CLEARFIELD CITY PLANNING COMMISSION MEETING AGENDA

1. Discussion and Possible Action on **PSP & FSP 2021-110038**, a preliminary and final subdivision plat request by Mike Bastian with Castle Creek Homes for a 9-lot single-family subdivision at the subject location. **Location:** 951 West 300 North (TINs: 12-019-0134 & 12-019-0135). **Project Area:** 2.16 Acres **Zone:** R-1-6 (Residential) **Staff:** Brad McIlrath, Senior Planner (**Administrative Action**).
2. Discussion and Possible Action on **CUP 2021-110103**, a conditional use permit request by Erin Carnley to open a school to teach the trade of Electrolysis at the subject location. **Location:** 1266 South Legend Hills Drive #B4 (TIN: 09-340-0201). **Zone:** C-2 (Commercial). **Staff:** Tyson Stoddard, Planner I (**Administrative Action**).

Project Information	
Project Name	Ball Fields Subdivision
Site Location	951 West 300 North
Tax ID Number	12-019-0134 & 12-019-0135
Applicant	Mike Bastian, Castle Creek Homes
Owners	Christopher Scott & Anissa Boestra; Castle Creek Homes LLC
Proposed Actions	Preliminary and Final Subdivision Plat Approval
Current Zoning	R-1-6 (Residential)
General Plan Land Use Classification	Residential

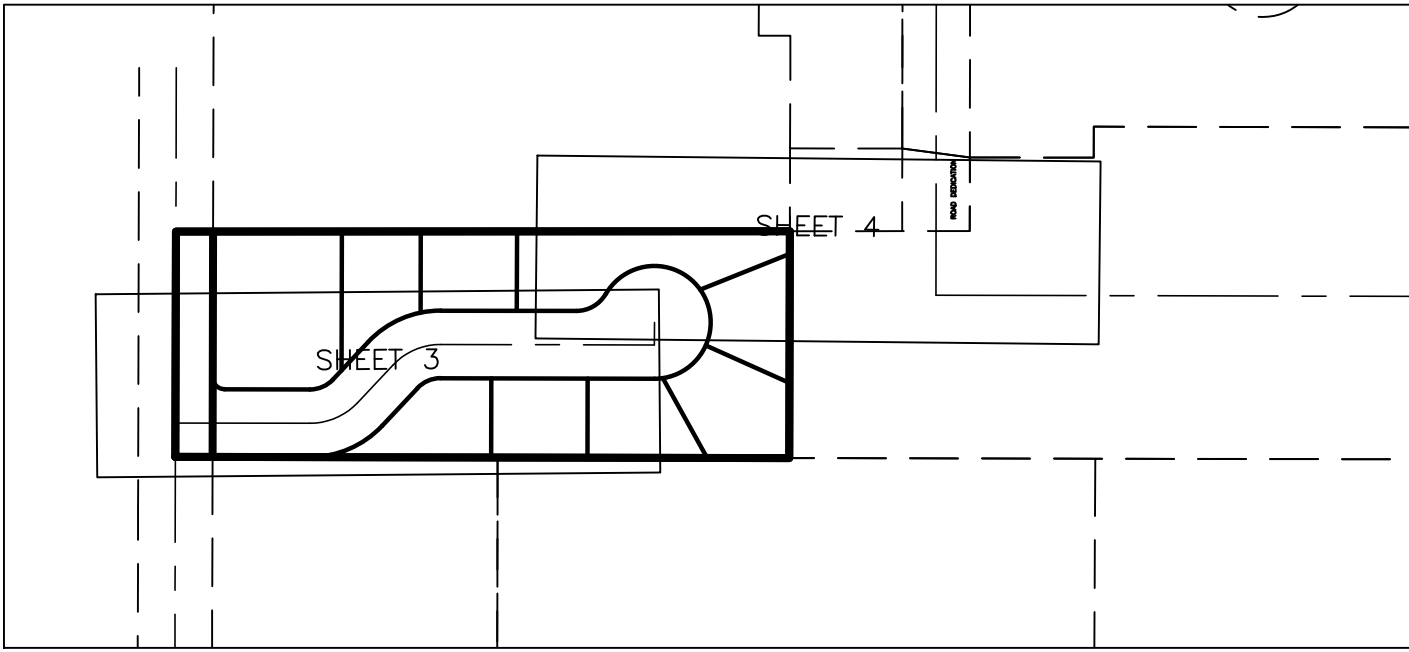
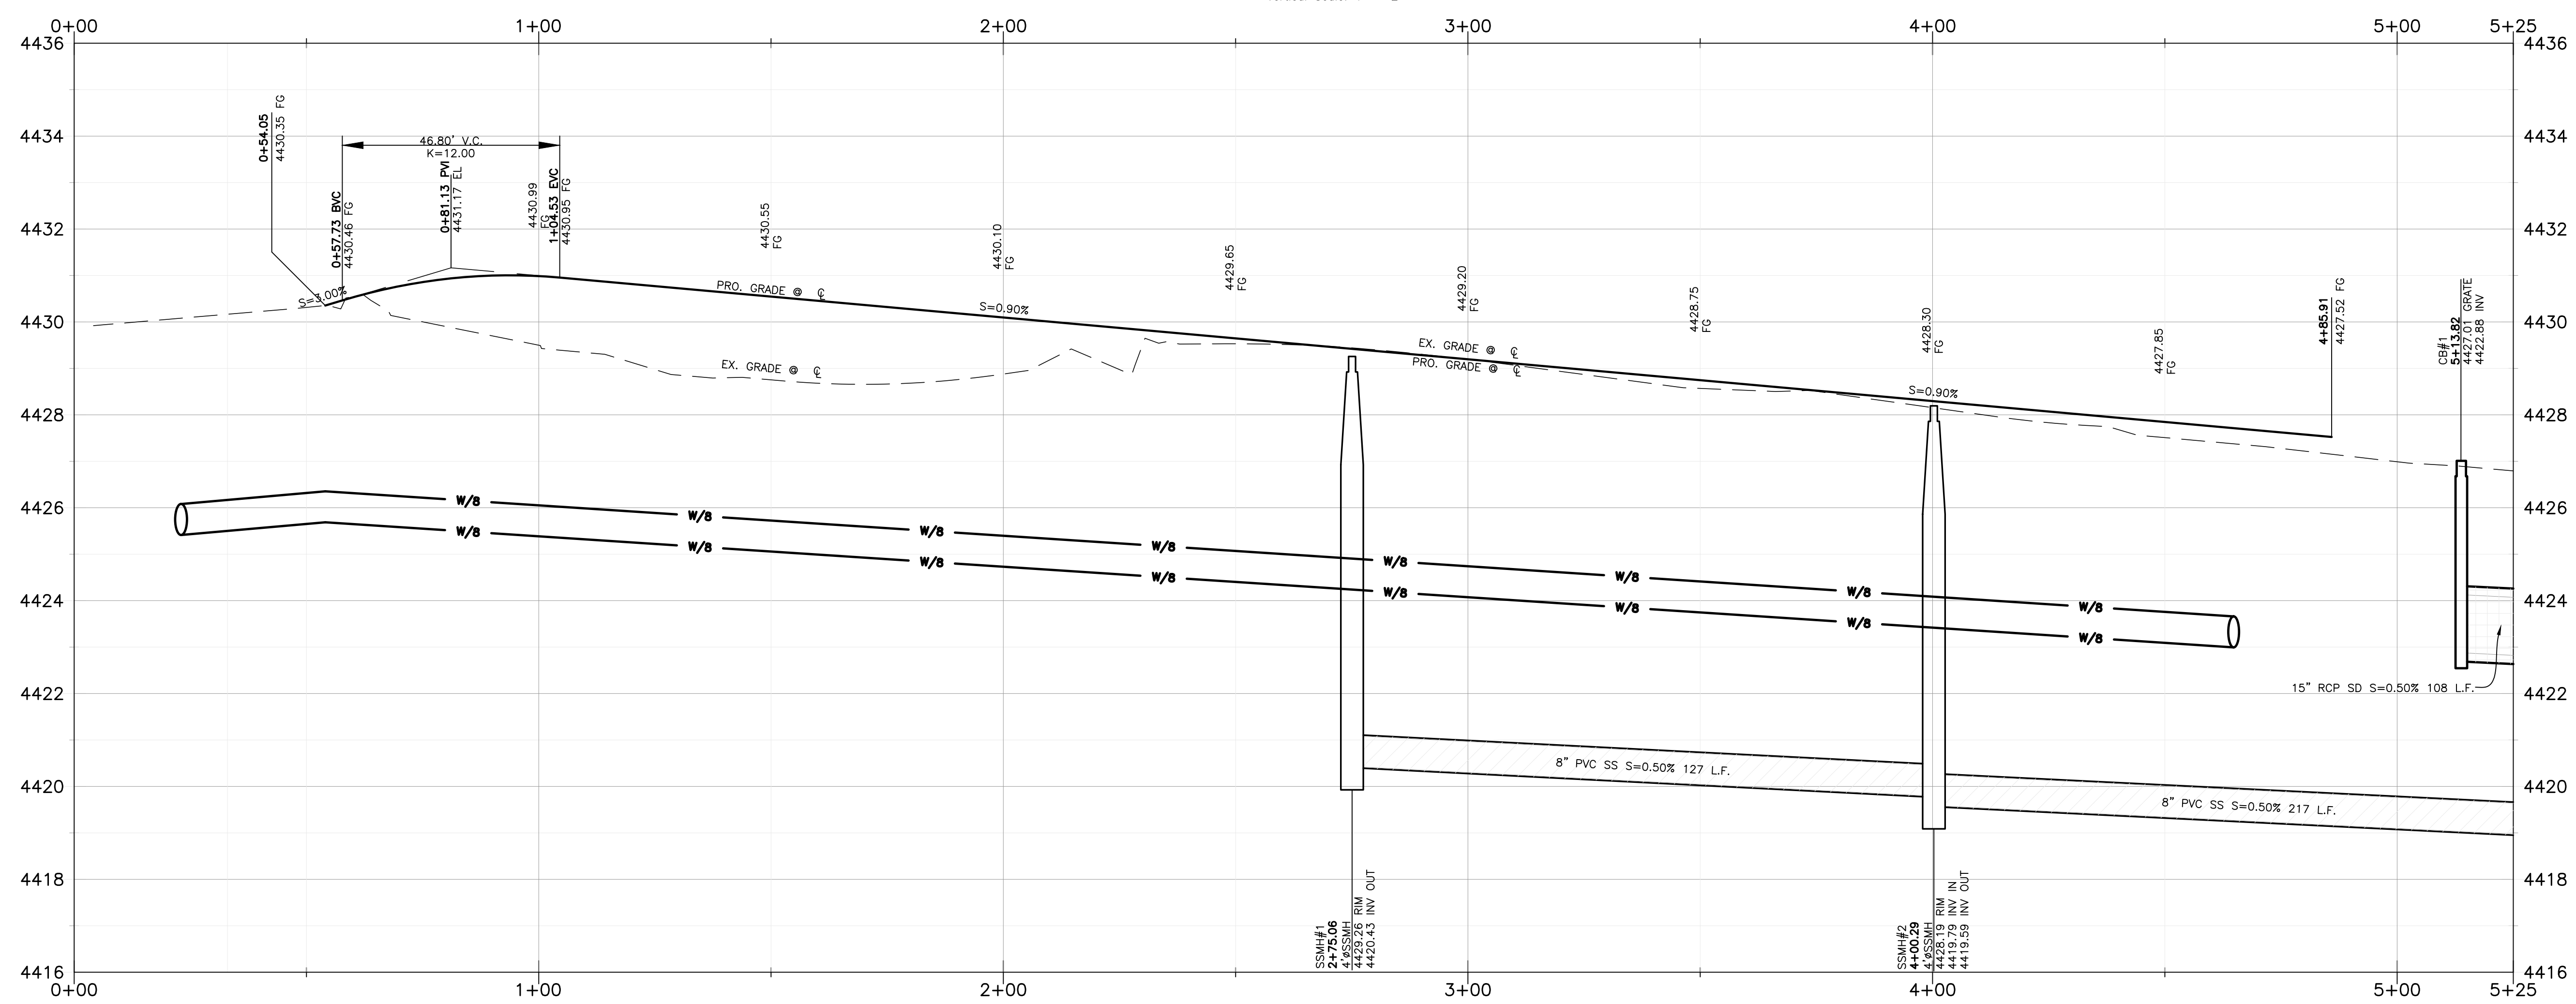
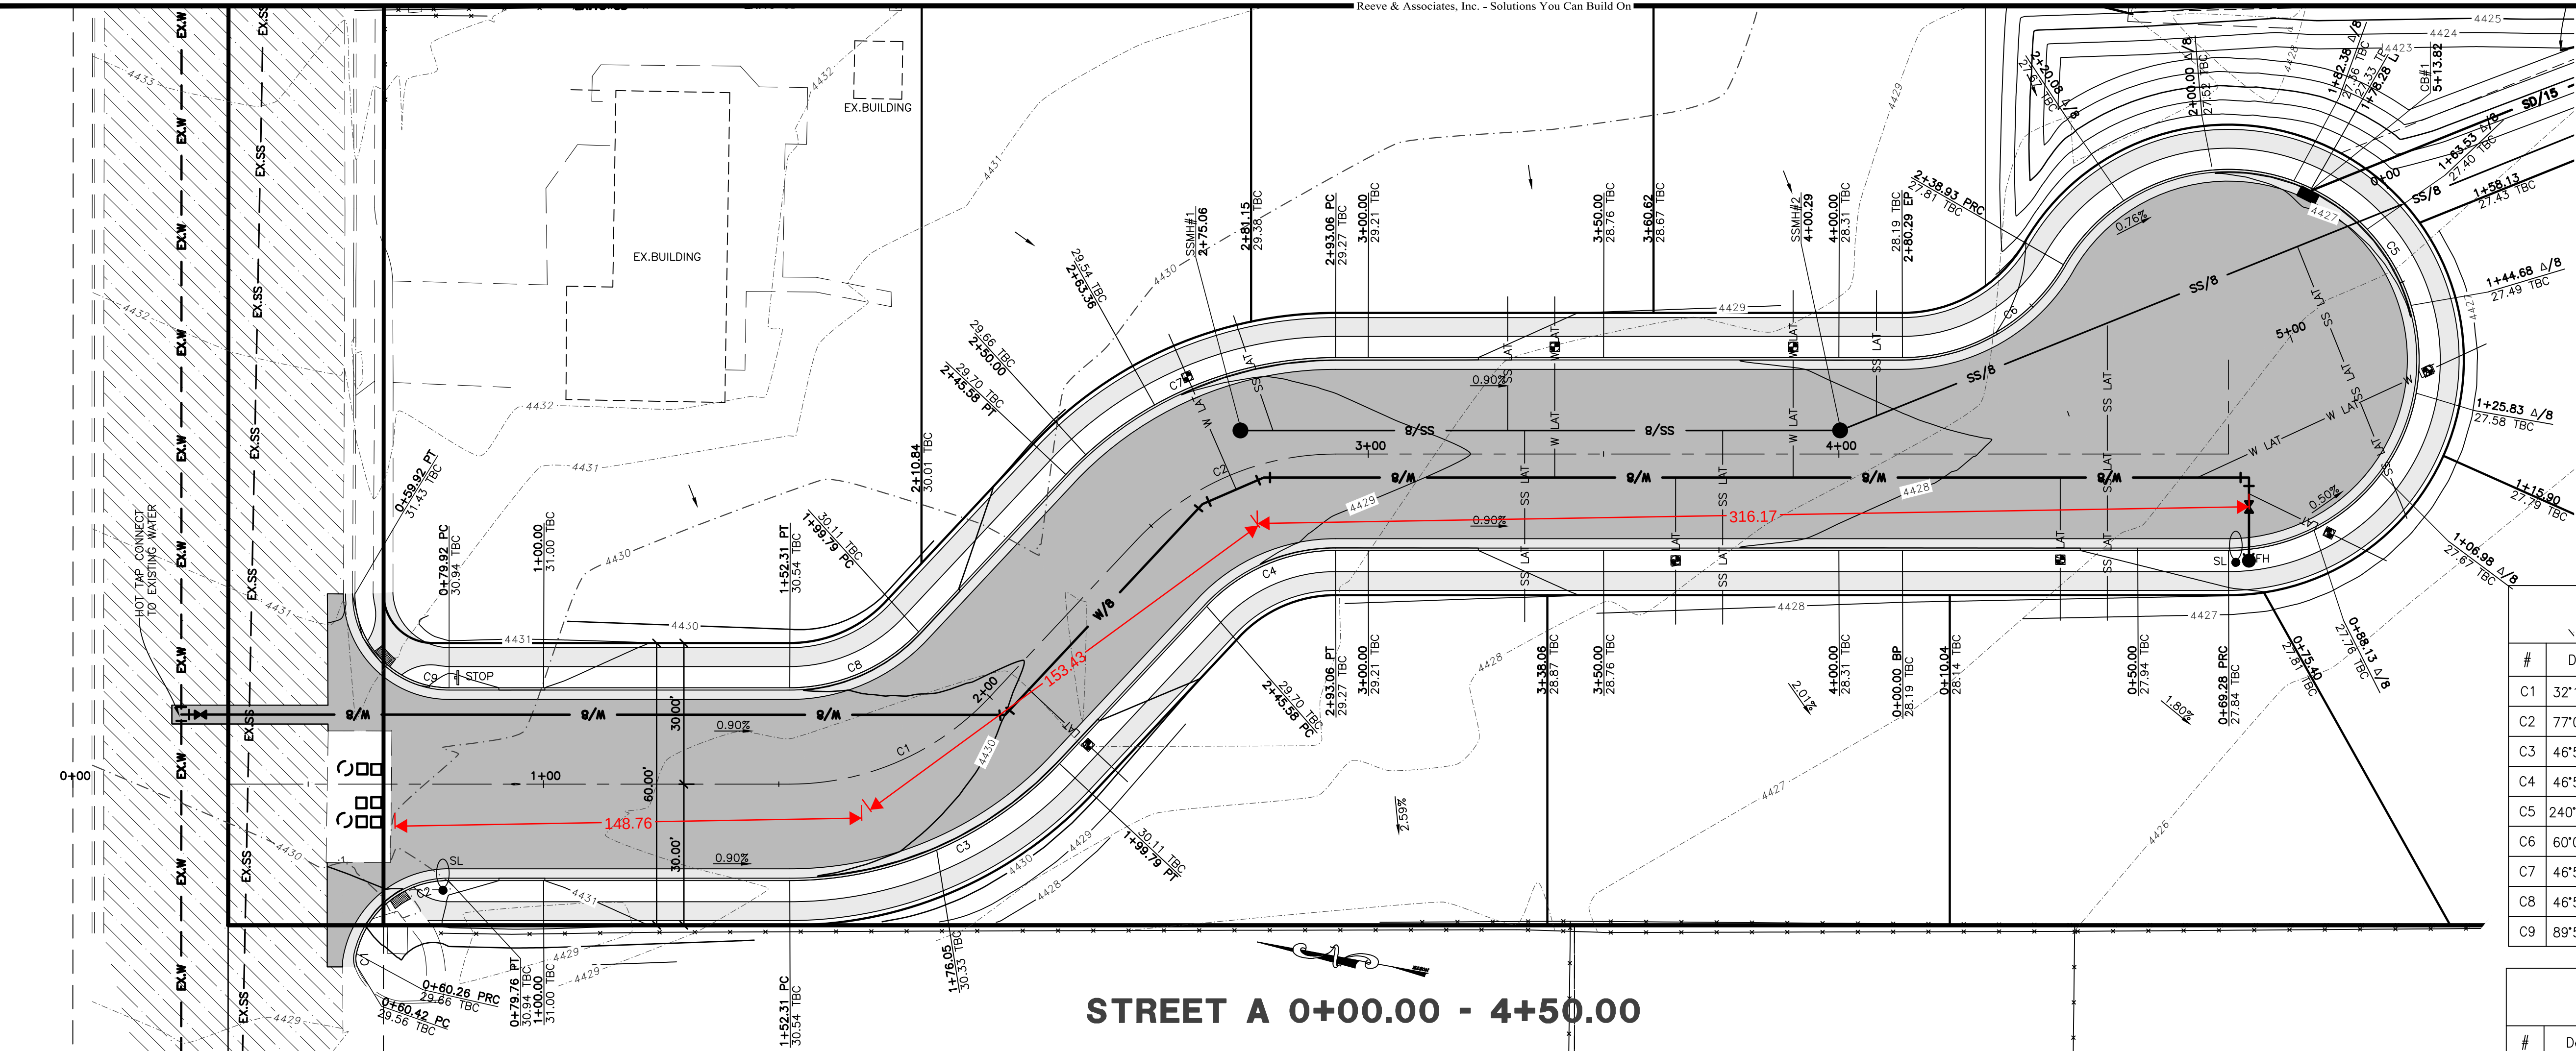
3. The street needs to be designated as a public road on the plat.
4. Lot addresses needs to be included on the plat
5. Cul-de-sac radius is only 40.5' to TBC on plans, our standards require 45.5' to TBC from center and 50.0' from center to property line. See standards drawings sheet 13 of 17 for details.
